APPLICATION NO.	FILING DATE	FIRST NAMED INVENTOR	ATTORNEY DOCKET NO.	CONFIRMATION NO.
10/522,507	01/17/2006	Igor Pereverzev	19339-100309	3456
7590	12/27/2007			
Robein W Asher Clark Hill 500 Woodward Avenue Suite 3500 Detroit, MI 48226-3435			EXAMINER FULTON, KRISTINA ROSE	
			ART UNIT 3673	PAPER NUMBER
			MAIL DATE 12/27/2007	DELIVERY MODE PAPER

Office Action Summary	Application No.	Applicant(s)
	10/522,507	PEREVERZEV, IGOR
	Examiner	Art Unit
	Kristina R. Gluchowski	3673

DETAILED ACTION

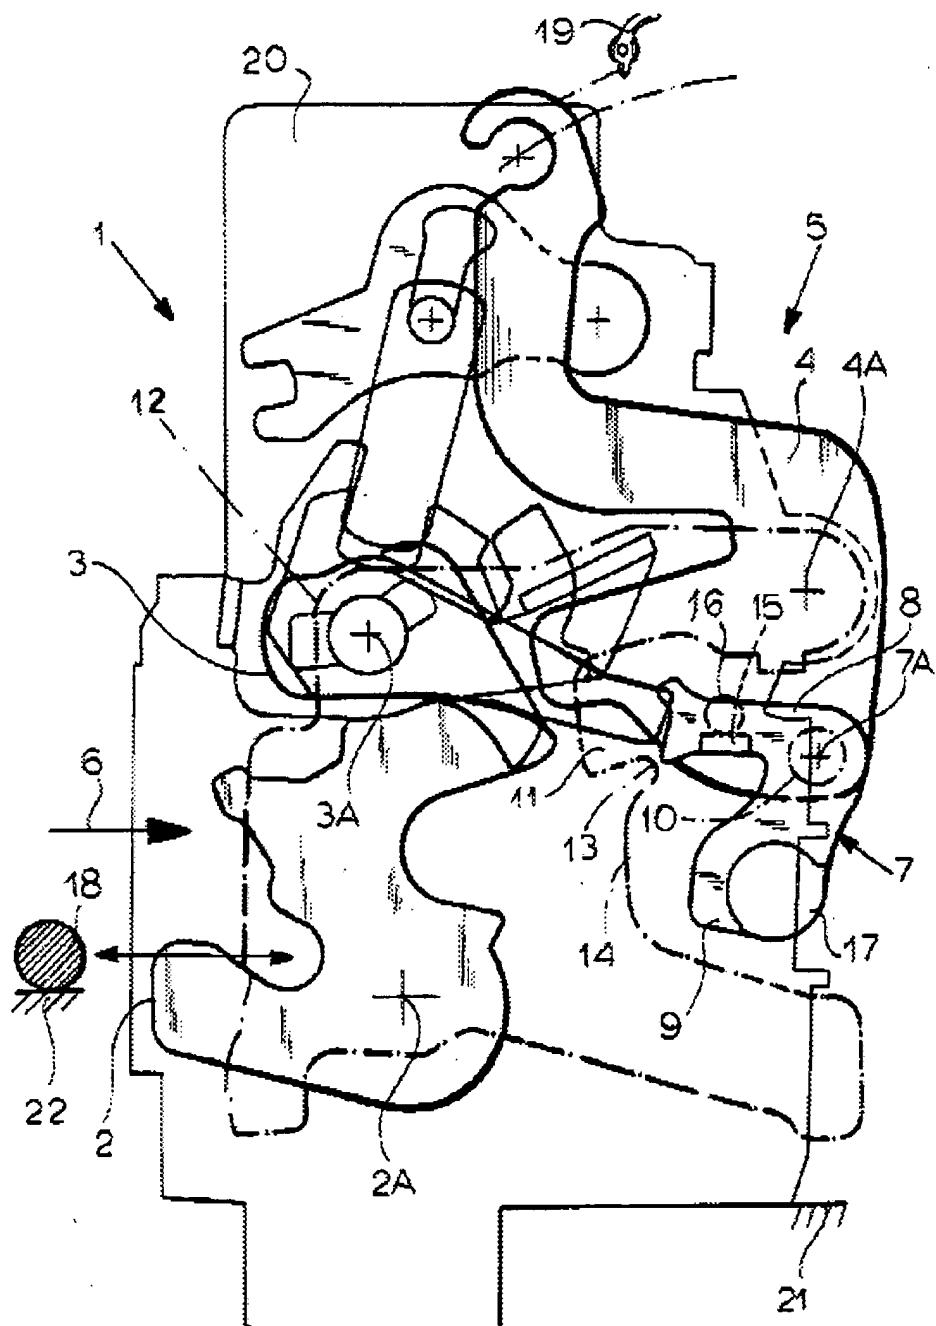
10. Regarding claim 1, "as best understood", Buschmann shows a latch mechanism for selectively latching a door to an automotive vehicle, said latch mechanism comprising a latch hook (2) movable between a locked position and an unlocked position; a release lever (4) operatively coupled to said latch hook for selectively moving said latch hook between said locked and unlocked positions; and an inertia lever (7) engageable with said release lever to prevent movement of said latch hook between

said latched and unlocked positions, said inertia lever movably supported within said latch mechanism for moving in and out of engagement with said release lever in response to a side impact upon the vehicle (column 3, lines 35-40); wherein said release lever includes a component (16) and the inertia lever includes a portion (15) for engaging the component (16). See the Buschmann device below.

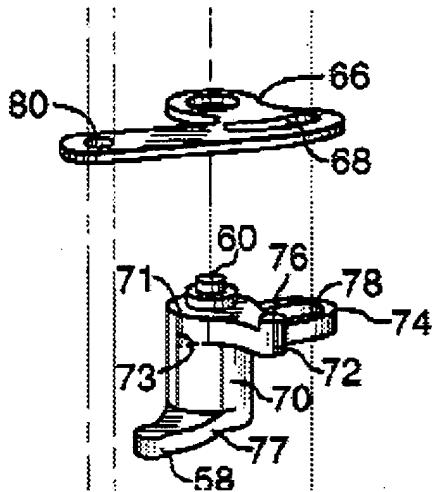
11. Although Buschmann shows applicant's basic inventive concept, the component (16) of Buschmann is not a slot. Cetnar shows that it is very well known in the vehicle latch art to include a tab and slot engagement. Cetnar shows that tab (76) is received in slot (68). It would have been obvious to one of ordinary skill in the art to replace the

component (16) of Buschmann with the slot (68) of Cetnar in order to assure proper alignment of the levers throughout complete motion of the inertia lever relative to the actuation lever. See the Cetnar device below.
